FEDERAL AVIATION AGENCY
BUREAU OF FLIGHT STANDARDS
Washington 25, D. C.

CIVIL AIR REGULATIONS DRAFT RELEASE NO. 61-12

SUBJECT: First Federal Aviation Agency Airworthiness Review

AIRWORTHINESS

FIG. 3-12(b)

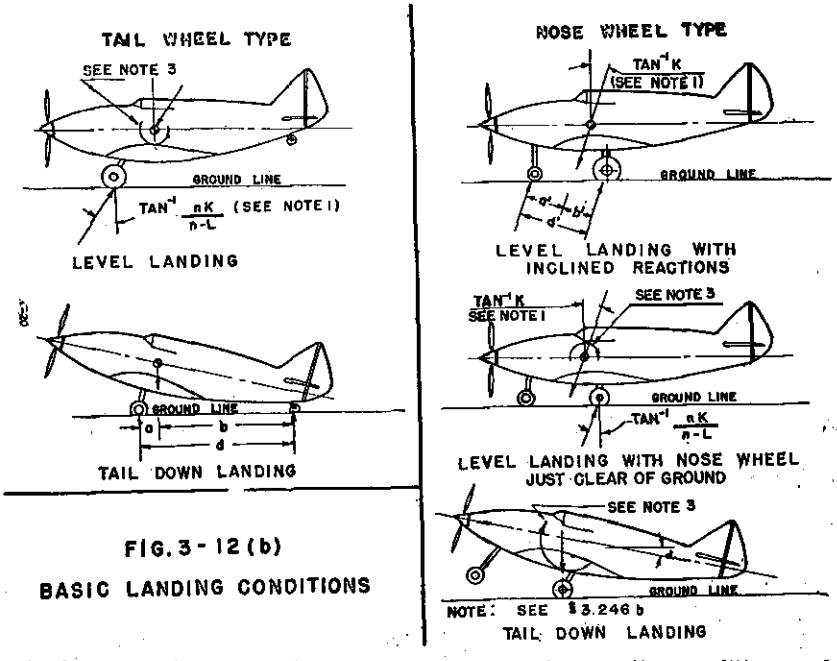
27. By amending Figure 3-12(b) referred to in § 3.244 as follows:
